Port Hedland Port Authority Utah Point Berth Project

RESPONSE TO PER SUBMISSIONS

- Rev 2
- 10 November 2008

■ Figure 5-1 Location of noise sources and noise receptors

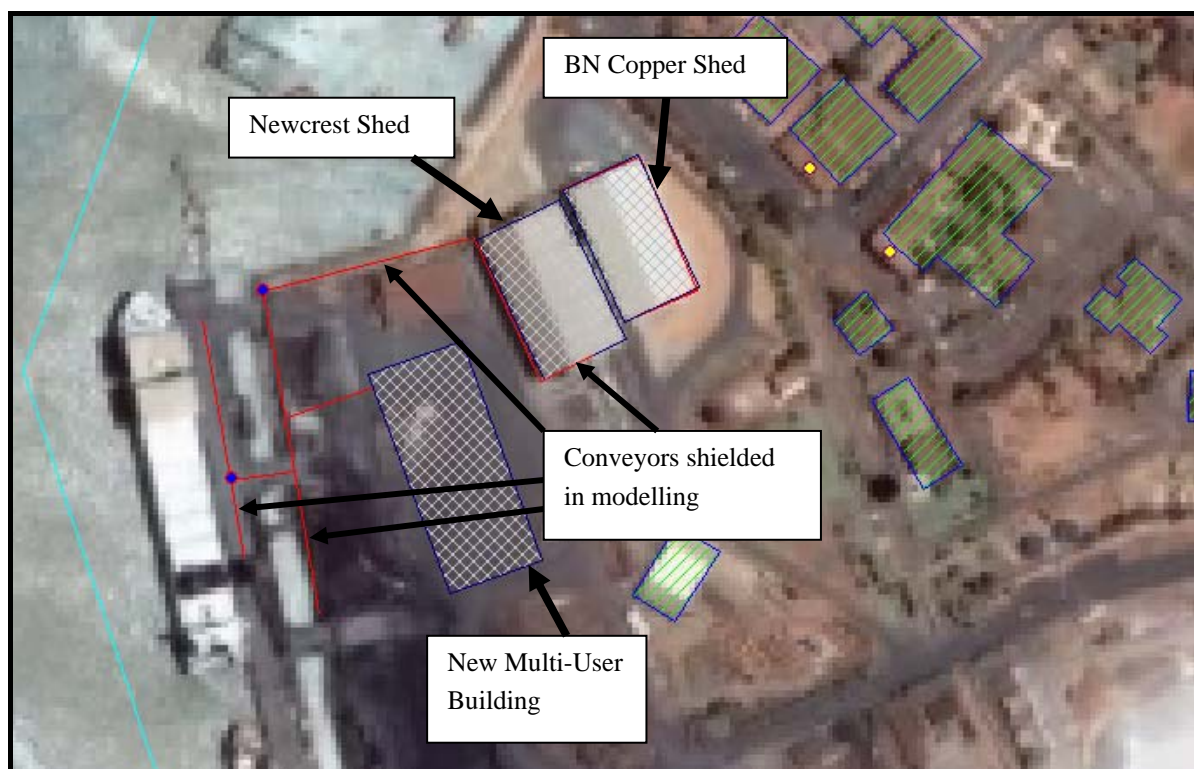
- (1) The proponent be required to provide more evidence/information to support its claim that the noise emissions in Port Hedland will be lower due to the UPBP.”*

For PHPA operations, best practice noise level reductions can be achieved by a combination of selection of low noise equipment (ie Front End Loaders), by shielding noise emissions due to conveyors and drives and also treatments such as installing internal acoustic linings on various faces of the buildings in the area. **Figure 5-1** shows the locations of the building and conveyors in the Port Hedland wharf area.

PHPA confirms that the noise model includes all relevant noise sources and that the list of relocated noise, decommissioned plant and new plant is accurate. **Section C** and **Section E** in **Section 5.1** above, present the findings of modelling to show how noise can be reduced with the development of UPBP. **Table 5-4** shows noise reductions possible from reduced activities at the existing berths and as a result of noise controls. **Table 5-5** shows noise levels associated with various configurations of UPBP and these noise levels are well below improved noise levels of existing berths.

■ **Figure 5-2 Utah Point noise sources**

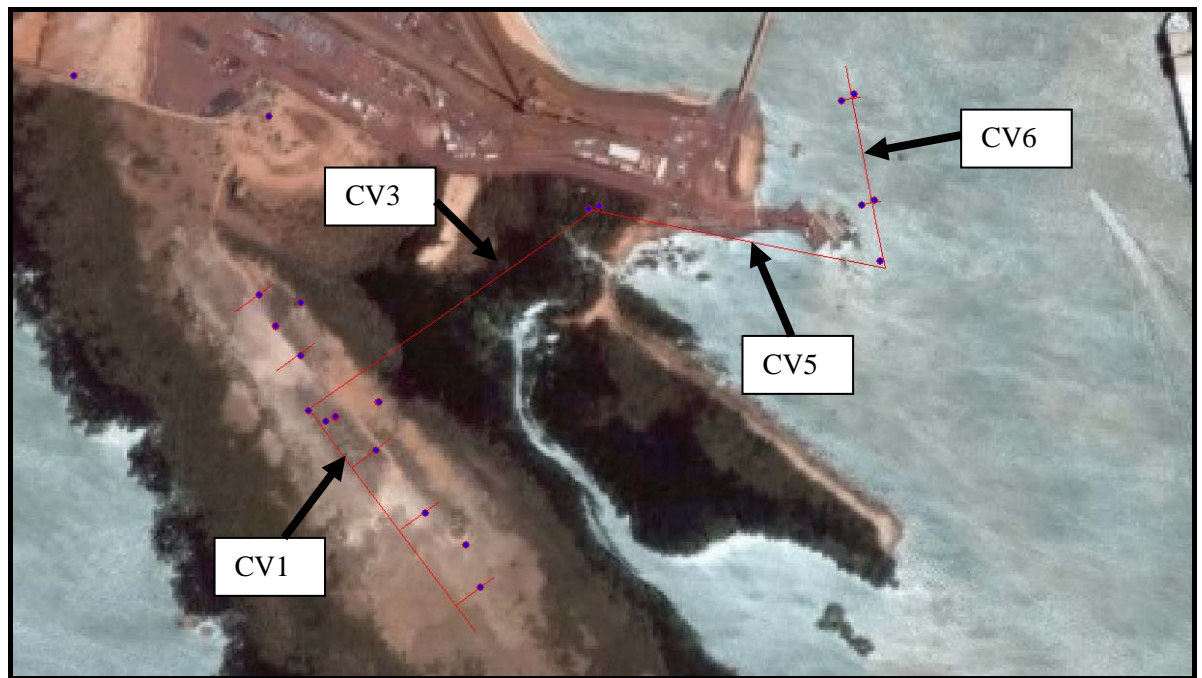
“It is predicted that the noise emissions either from the proposed Utah Point Berth Project (UPBP) or from the future PHPA operations at three public berths in Port Hedland will not be able to comply with the assigned noise levels, even though the PER document states in Section 7.8.1 Noise Management Objectives that one of the key objectives is ‘to ensure that noise emission, both individually and cumulatively, comply with the appropriate statutory requirements’.

Though the Noise Branch agree that the noise impact from the proposed new berth at Utah Point should be assessed together with the PHPA port operations in Port Hedland, the new berth at Utah Point is obviously new infrastructure, and should be designed to meet the noise regulations. According to EPA draft Guidance No. 8 – Environmental Noise (Page 7): “Where a proponent proposes an upgrade to an existing facility that does not comply with the assigned levels, the proponent must, as part of the EPA assessment:

- *provide and commit to a Noise Improvement Plan, detailing measures that will be taken, and timelines for completion, to ensure that existing noise emissions will be brought into compliance; and*
- *provide a detailed assessment demonstrating that the proposed new plant to be installed will, by itself, emit noise below the assigned levels, such that the overall plant noise emissions will eventually comply.”*

Figure 5-2 shows the arrangement of the Utah Point noise sources.

Best practice noise control for the Utah Point Berth Project involves using enclosed drives for conveyors, stackers and ship loaders. Shielding conveyor emissions by means of acoustic barriers will also reduce noise levels. The barriers are assumed to provide 12 dB reduction for the conveyor noise emissions and the drive enclosures are modelled to provide at least 10 dB reduction in the overall PWL of each drive.

■ **Figure 7-5 Predicted 24-hour average PM₁₀ at the Harbour monitoring site including background concentrations**

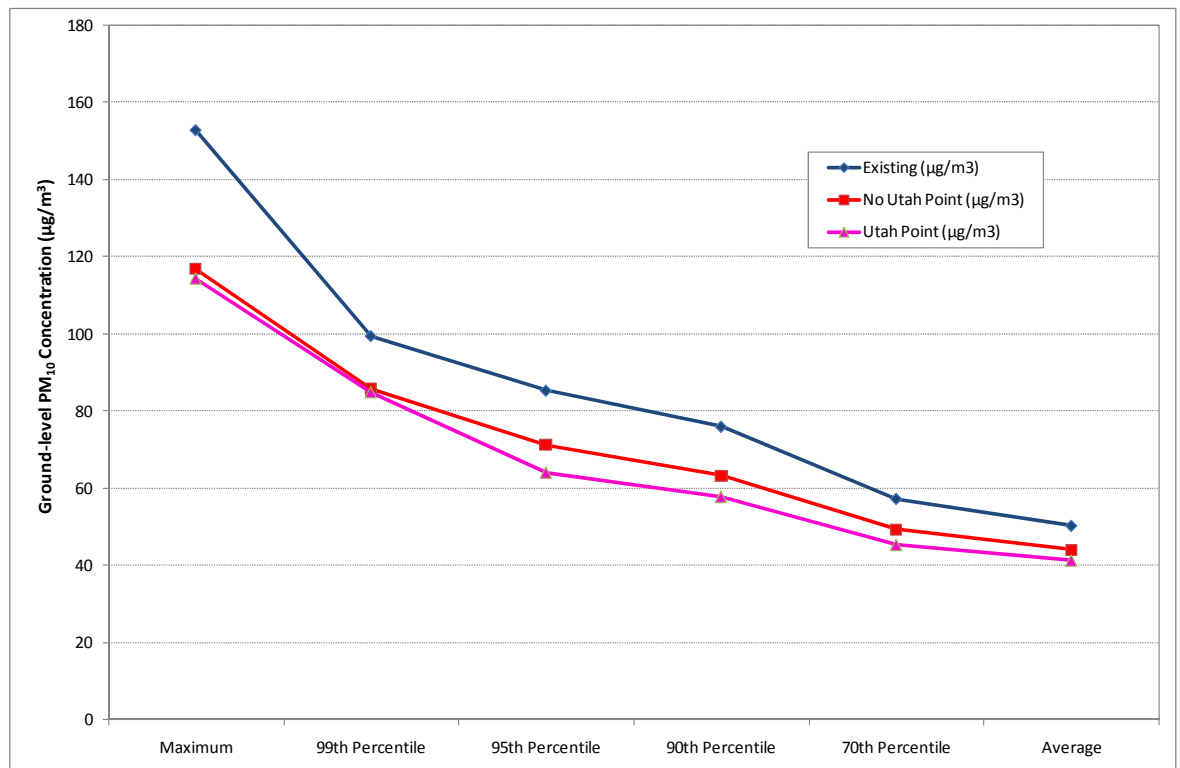
‘The omission of background particulate matter data in Port Hedland in the assessment strategy. DOH would like to reiterate that historic and recent (2006) dust monitoring data and modelling results indicate that particulate matter in the ‘west end’ of Port Hedland is problematic. The use of background data obtained from Port Hedland airport as confirmation for background levels for the port precinct of Port Hedland is inappropriate as it does not reflect the air shed of the port area. DOH reiterates that the current proposal will significantly add to the overall burden of particulate matter in the air shed over the ‘west end’ of Port Hedland.’”

A statistical comparison between the predicted PM₁₀ concentrations from the current scenario, Proposed Utah Point development scenario, and the No Utah Point development scenario at the Harbour monitor is presented in **Figure 7-5**. The results in this figure include the background concentration file supplied by BHPBIO. From this figure it is evident that it is predicted that the proposed Utah Point development will result in lower concentrations at the Harbour monitoring station.
